BUSCONNECTS –C4 Finglas to Phibsborough Corridor

Accessibility Audit Report

14 of 18

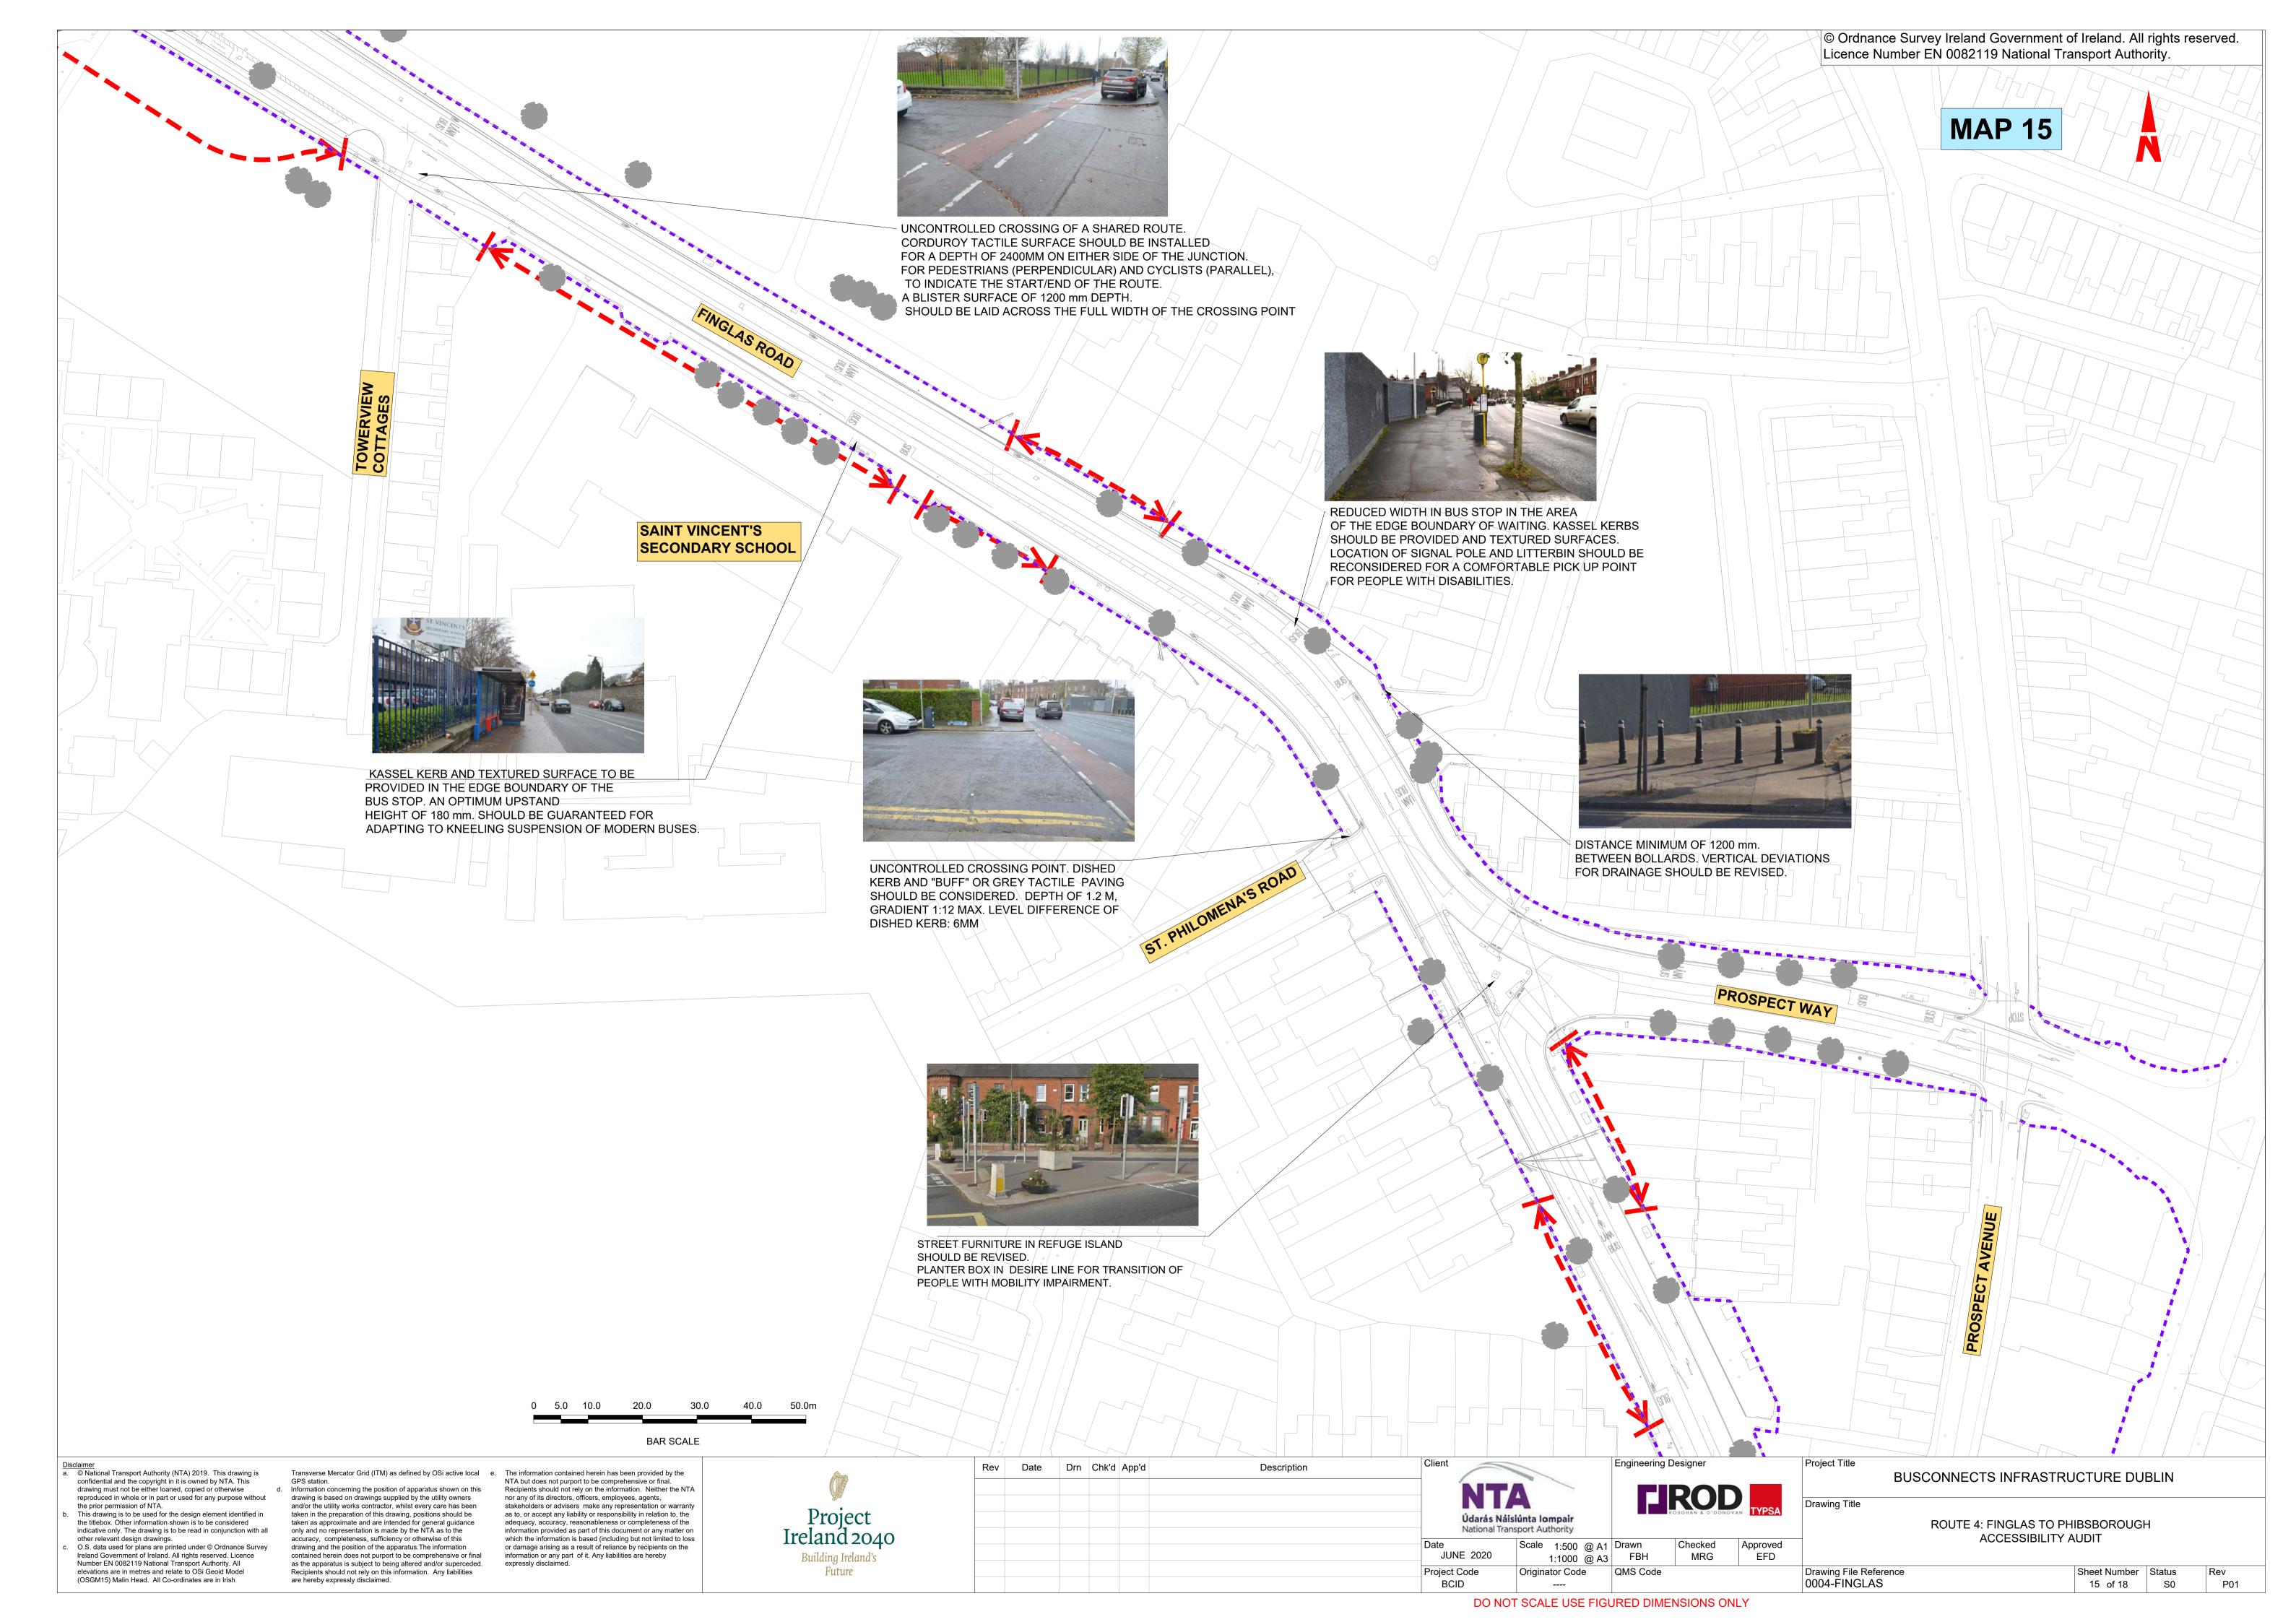
THE POSITION OF THE PLANTER BOX IN THE REFUGE ISLAND SHOULD BE REVIEWED BECAUSE IT IS IN THE LINE OF MOVEMENT OF PEDESTRIAN AND PEOPLE WIT MOBILITY IMPAIRMENT, STREET FURNITURE SHOULD BE INSTALLED ALSO AS A PROTECTIVE ELEMENT CLOSE TO BOUNDARIES
